# Memorandum

**To:** Beth Boepple, Chair, and Members of the Portland Planning Board  
**From:** Nell Donaldson, Planner  
**Date:** November 5, 2015  
**Re:** AC Hotel, 158 Fore Street  
**Project #:** 2015-169 **CBL:** 19-B-2  
**Meeting Date:** November 10, 2015

Figures 4 and 5: Rendering of 158 Fore from Fore/Hancock Streets (top); preliminary site plan.

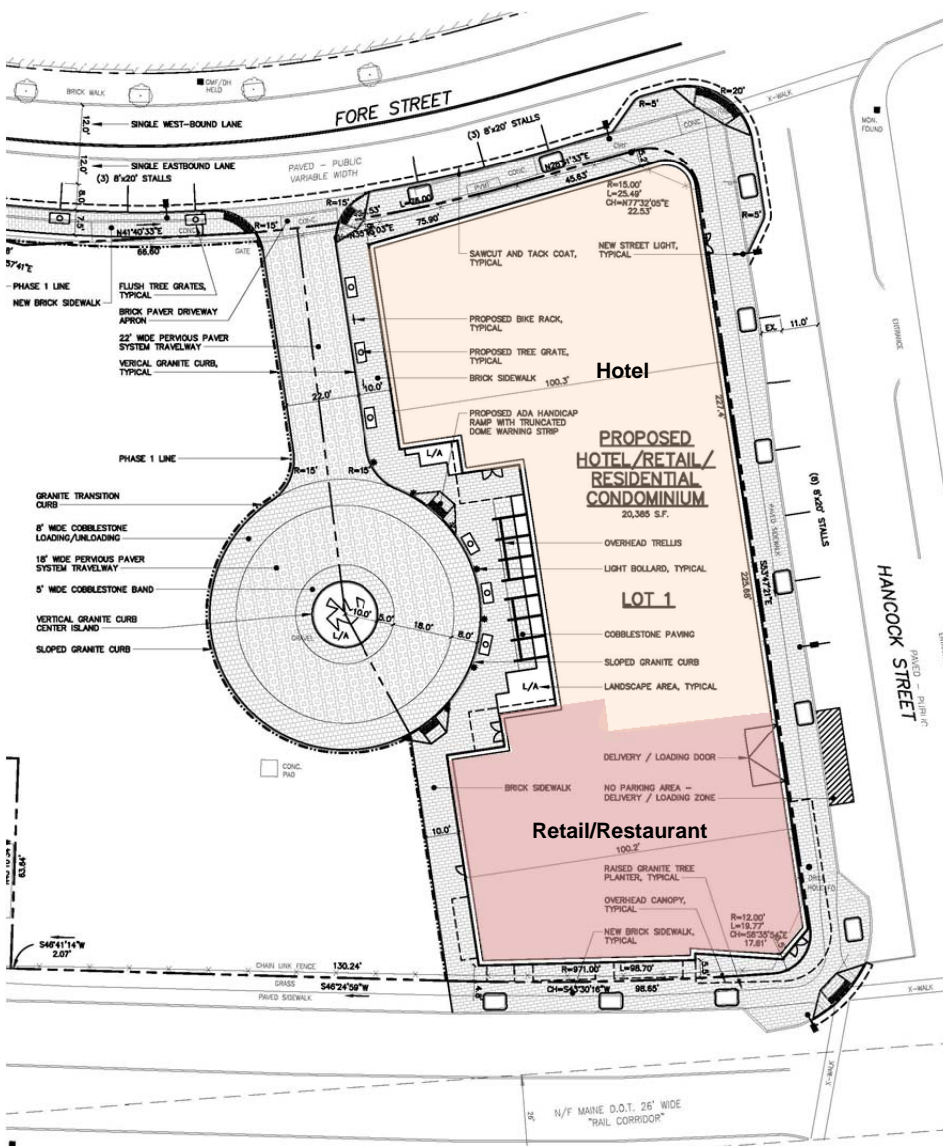
A portion of the project also falls within the Shoreland zone. However, none of the proposed structures would lie within 75 feet of the normal high water line. Per discussion with Ann Machado, the city's zoning administrator, the project complies with the city's Shoreland zoning ordinance. The Shoreland zone should be depicted on the revised survey and site plan.

In terms of circulation on the site, the preliminary plans show a 22' drive at the rear of the proposed hotel. This alley terminates in a one-way circle with a landscaped island at center, although the applicant has indicated the intent to carry this drive through to Thames Street under future phases of development. Vehicular access to the hotel would occur from this circle, as would vehicular access to the upper floor residences, as the major entries to both of these uses are proposed off the circle area. Vehicular access to parking would occur at the western end of the Ocean Gateway garage opposite Fore Street. Mr. Errico has reviewed the design and notes,

*The driveway apron material does not meet City design standards and I will refer this issue to DPS.*

*Detectible warning panels are not required at the site driveway. I would suggest tip-down curbing for improved sidewalk slope conditions.*

Regarding pedestrian access, staff has requested that the applicant review the location of the hotel entrance on the north end of the building near the intersection of Fore and Hancock, as it seems inconsistent with the likely travel patterns to and from the site. Staff has also requested that the applicant document that ADA-compliant access to the building is proposed. On the topic of ADA access, Mr. Farmer notes,

*The circular driveway plans show accessible sidewalk ramps adjacent to granite cobblestone pavement in the driveway. The granite cobblestones would look nice; but, I wonder if the cobblestone surface can be constructed smooth enough to meet ADA design standards.*

The preliminary plans include two bicycle racks on the alley and internal bicycle parking is referenced in the narrative. Staff has requested that the applicant show the location of interior bike storage and confirm the number of bicycle spaces required pending Mr. Errico’s review of the parking generation analysis. The total bicycle parking requirement, based upon the applicant’s preliminary numbers, is 18 spaces.
